Future Direction and Recap

General Themes / additional points

Figure 2

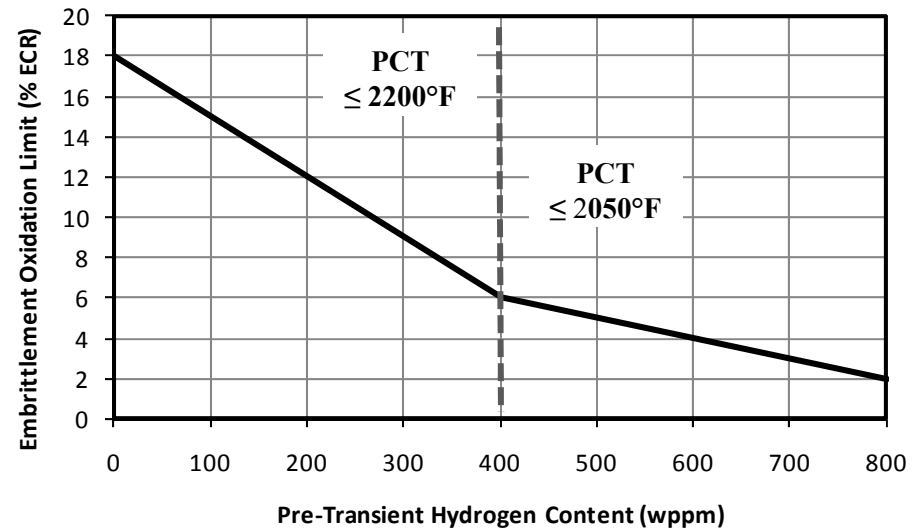
NRC is considering:

New alloy's that (1) use the same reduction method, (2) operate less than or equal to the maximum fluence, (3) include only the alloying elements present in the materials tested and (4) have similar alloying content of each element to the materials tested, then a reduced level of testing could be considered to adopt figure 2.

- As-received (AR) material
- Reduce pre-hydrated testing to only 2 [H] levels
- Eliminate testing of irradiated material

Default definition of “similar” as 10% deviation from alloying limits defined for tested alloy

Alternative definitions of “similar” can be proposed and reviewed

Figure 2

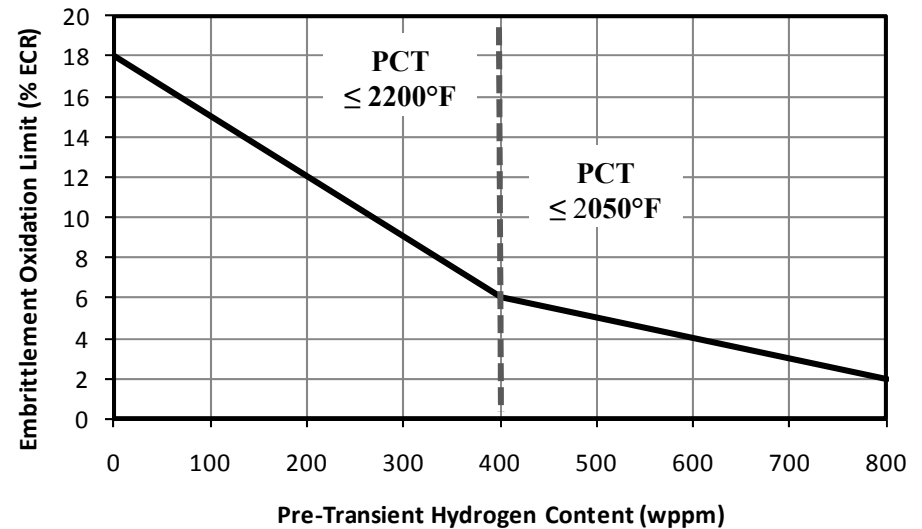
Alternatives proposed in comments and during discussion:

- Alloys that fall in the above range can use Figure 2 without testing
- Total alloying content <2.2% can use Figure 2 without testing
- Testing of an alloy used to develop Figure 2 in combination of a new alloy, showing similar behavior to the tested alloy, should be acceptable to adopt Figure 2.
